## Encoder Issue in MR-J5 HK Servo Motor

May 22, 2023

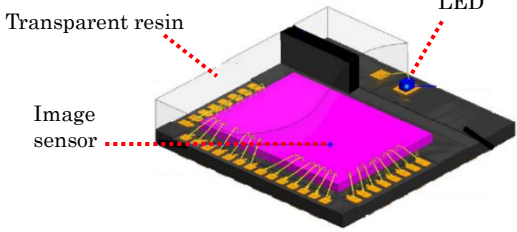
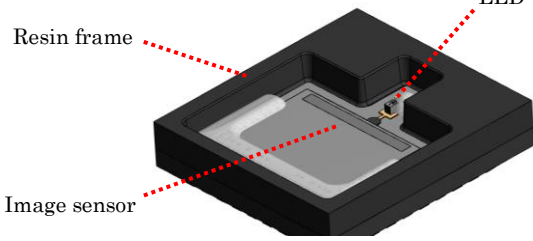
As a countermeasure, the design has been sequentially changed from one whose entire part is covered with resin (Figure 6) to one without resin (Figure 7).

Design before change	Design after change
 <ul style="list-style-type: none"> <li>• The LED and image sensor are entirely covered with transparent resin molding. (for protection during assembly) → A line appears in the LED (which causes the failure) due to the stress caused by temperature drop after resin molding.</li> </ul> <p>Figure 6 (Light transmitting/receiving module with the design before change)</p>	 <ul style="list-style-type: none"> <li>• Resin is not used for the upper parts of the LED and image sensor. → Since there is a space around the LED, the compressive stress will not be applied to the LED.</li> <li>• The resin frame is added to the peripheral part of the LED and image sensor. (for protection during assembly)</li> </ul> <p>Figure 7 (Light transmitting/receiving module with the design after change)</p>

Figure 8. Conceptual figure of the diagnosis function in the batteryless absolute position encoder

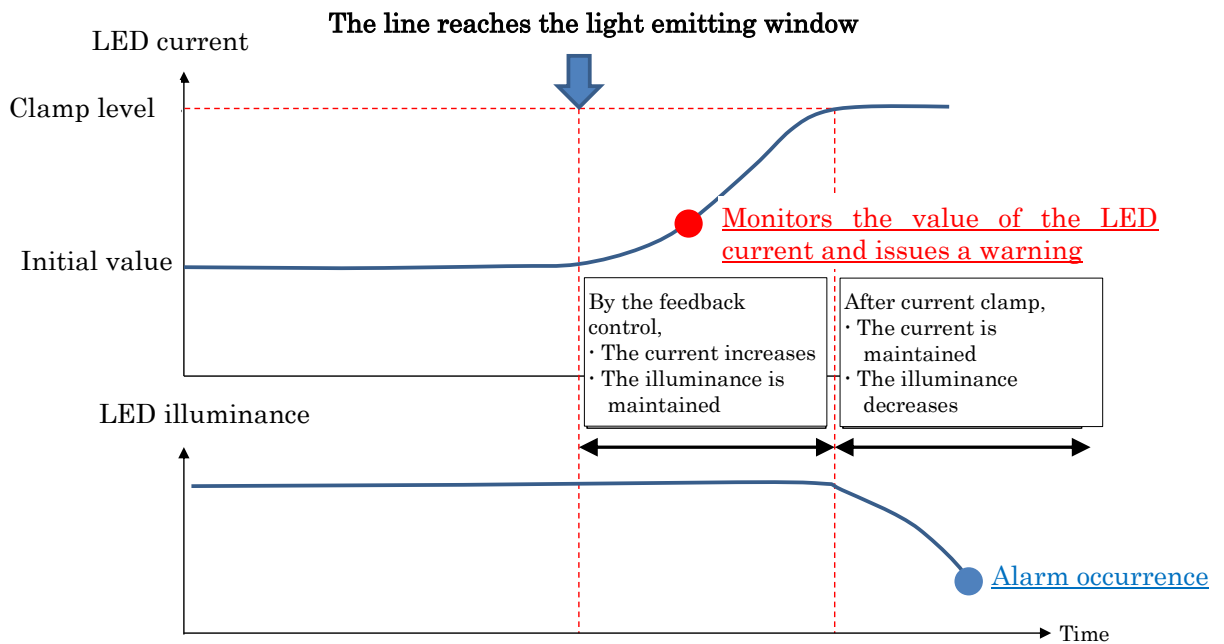
To detect signs of line development on the LED before LED illuminance decrease occurs causing an alarm (AL021.1), the diagnosis function has been added to the AC servo amplifier MR-J5 (with firmware version D1 or later).

As shown in Figure 8, if the line on the LED edge surface extends into the light emitting window, the LED current feedback control inside the encoder increases the LED current value to make the illuminance even. After the LED current value reaches the clamp level, the LED current value becomes even and the LED illuminance decreases. Therefore, monitoring the LED current value enables detection of signs of illuminance decrease. This diagnosis function cannot detect symptom 2 mentioned below because the function is applicable only to symptom 1. The latest firmware version of the MR-J5 is available by downloading from the Mitsubishi Electric FA site. To enable this function on servo amplifiers with firmware version D1 or later, some of the undisclosed parameters need to be changed. Please contact your local sales office when introducing this function.
